**Comments of Pacific Gas and Electric Company**  
***Bid Cost Recovery and Variable Energy Resource Settlement –***  
***Straw Proposal 4/9/15***

Pacific Gas and Electric Company (PG&E) offers the following comments on the California Independent System Operator's (CAISO) Bid Cost Recover (BCR) and Variable Energy Resource (VER) Settlement April 9<sup>th</sup> Straw Proposal.

Figure 1. Pre-Fifteen Minute Market Process

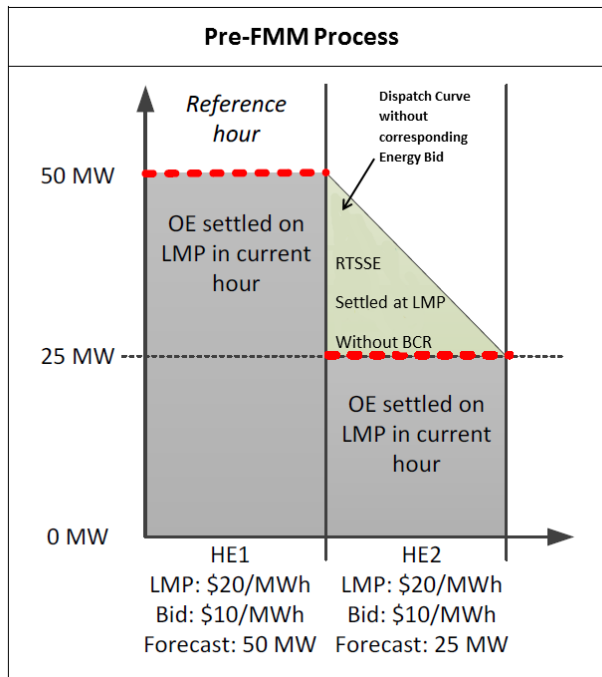
Before the start of the Fifteen Minute Market (FMM) FERC 764, the energy associated with an unbid downward shift in a unit's energy output was classified as Real Time Self Scheduled Energy (RTSSE) and was settled at the 5-minute LMP (See Figure 1). This energy was also ineligible for Bid Cost Recovery (BCR) payments and did not affect the resource's overall BCR position for the day.

Figure 2. Current Settlement Process

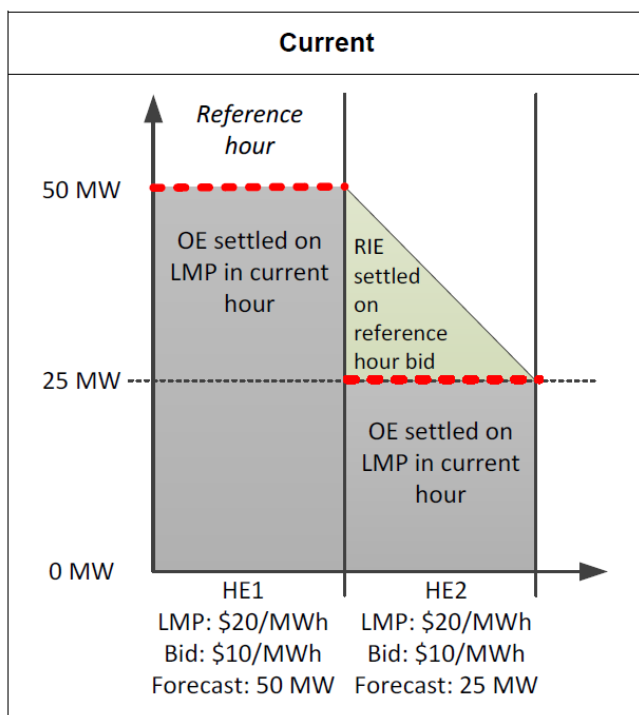
With the removal of the RTSSE classification this energy then began being classified as Residual Imbalance Energy (RIE). This reclassification introduced an inconsistency with the previous process since RIE may be settled at a price different from the corresponding 5-minute LMP and is also considered for purposes of BCR, using the reference hour bid price to establish its cost basis (See Figure 2).

Figure 3. CAISO's Proposed Settlement Process

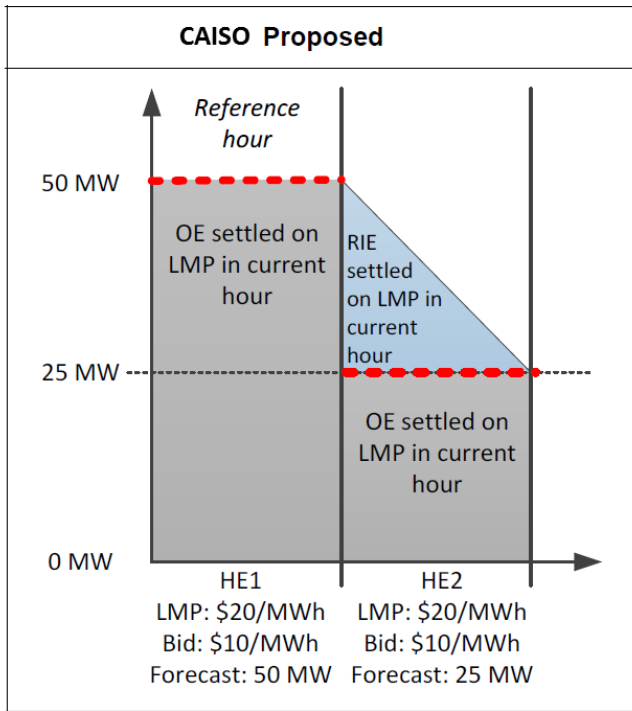
Under the CAISO's proposed solution, the resulting RIE would instead be settled only against the 5-minute resource LMP (See Figure 3). This RIE would still be used in calculating and modifying BCR values for the day however. PG&E believes this is inconsistent with prior energy classifications and with the details discussed during the stakeholder process. The continued use of RIE also raises questions concerning the marginality of the resulting unbid energy. In this case the energy in the triangle is neither economically bid nor self-scheduled and, as such, is neither infra-nor extra-marginal.

Figure 4. PG&E's Proposed Settlement Process

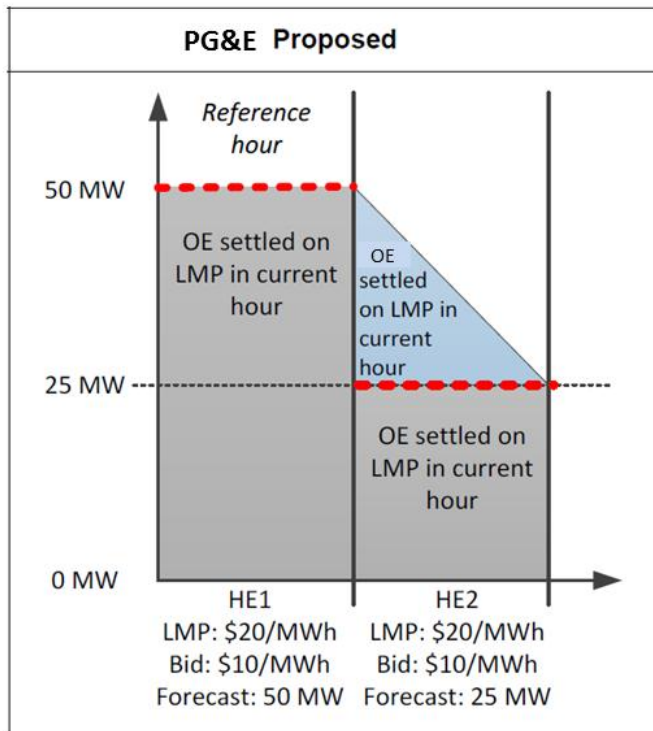
PG&E believes that a more accurate representation for this condition would be to use the OE energy type and use the resource's 5-minute LMP for both settlement and cost basis (See Figure 4). This would pay the resource appropriately for the energy produced without allowing for any possible exploitation of BCR. This process is also consistent with how similar energy is classified when produced by a conventional resource. PG&E believes that when resources participate in the market using similar mechanisms, the results of such participation should be evaluated and settled in a consistent manner, regardless of the resource's technology type.
